**SITE PLAN - HILL COUNTRY ROADWAY PERMIT REVIEW SHEET
APPEAL TO CITY COUNCIL BY AN INTERESTED PARTY**

CASE NUMBER: SPC-2009-0349C **HEARING DATE:** December 16, 2010

PROJECT NAME: The Trails at 620

TO: Sarah Graham, Case Manager
CC: Members of the Zoning and Platting Commission
FROM: Shandrian Jarvis, Transportation Planner
DATE: October 26, 2010
SUBJECT: SPC-2009-0349C Trails at 620 -Traffic Analysis Update

FIGURE 1
CONCEPTUAL
SITE PLAN

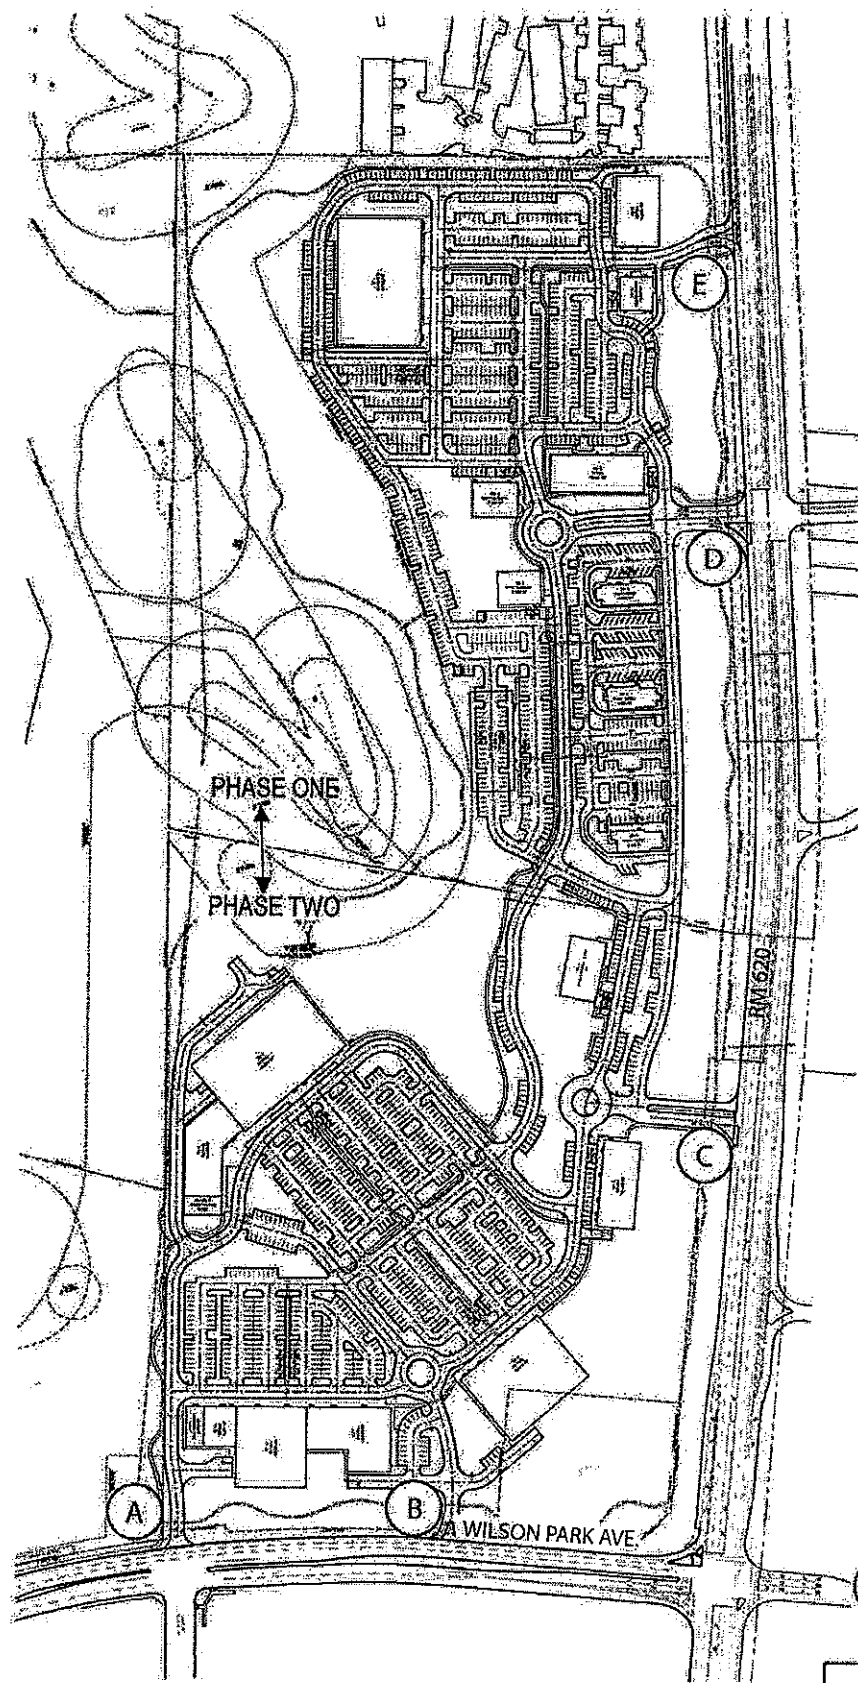
The purpose of this study was to evaluate two driveway scenarios for the property and determine the effects on area traffic flow. The first, Scenario 1, assumes that there will only be two site driveways on RM 620. These are Driveways C and D, as shown in Figure 1. Driveway C is located north of Wilson Parke Avenue and would form a T-intersection with RM 620. Driveway D forms the fourth leg of the RM 620 and Concordia University Drive intersection. In Scenario 2, a third driveway, Driveway E, is proposed to be located north of the Concordia University Drive intersection and would function as a right-in/right-out only driveway. Therefore, this study analyzed the following two scenarios:

Analysis results indicate that provision of a third site driveway (Driveway E) designed as a right-in/right-out only driveway with a deceleration lane - Scenario 2 - will benefit traffic operations along RM 620 in addition to internal traffic flow. This will allow traffic from the north on RM 620 to circumvent the traffic signal at the RM 620/Concordia University Drive intersection, which reduces the traffic demand that the signal must handle. In fact, delay at the intersection of RM 620 and Concordia University Drive is reduced by 40% with the addition of the third driveway.

Wilson Parke Avenue. It is recommended that this driveway (Driveway E) be constructed as a right-in/right-out only driveway with a deceleration lane; therefore, there will be no additional left-turn maneuvers created by this driveway. It's proximity to the proposed movie theater will be particularly helpful in moving traffic into the site in an efficient manner. The ability for southbound traffic on RM 620 to make an unrestricted right turn into the site immediately prior to the traffic signal creates a unique opportunity to relieve congestion on RM 620 through the placement of the third driveway.

2. If permitted, the proposed third driveway (Driveway E, Attachment 1) should be constructed as a right in/right out only driveway with a deceleration lane as part of the site development phase of the project. Prior to the release of the site development permit, the applicant should post fiscal for the estimated cost to construct the deceleration lane. Deceleration lanes serving only one project (e.g. left or right turn lanes at a private driveway) are funded 100 percent by the applicant. The applicant should submit a schematic drawing with dimensions and a construction cost estimate signed and sealed by an engineer to verify the amount required for posting. It is recommended that these improvements be implemented by the applicant to assure safer access and circulation into the site.
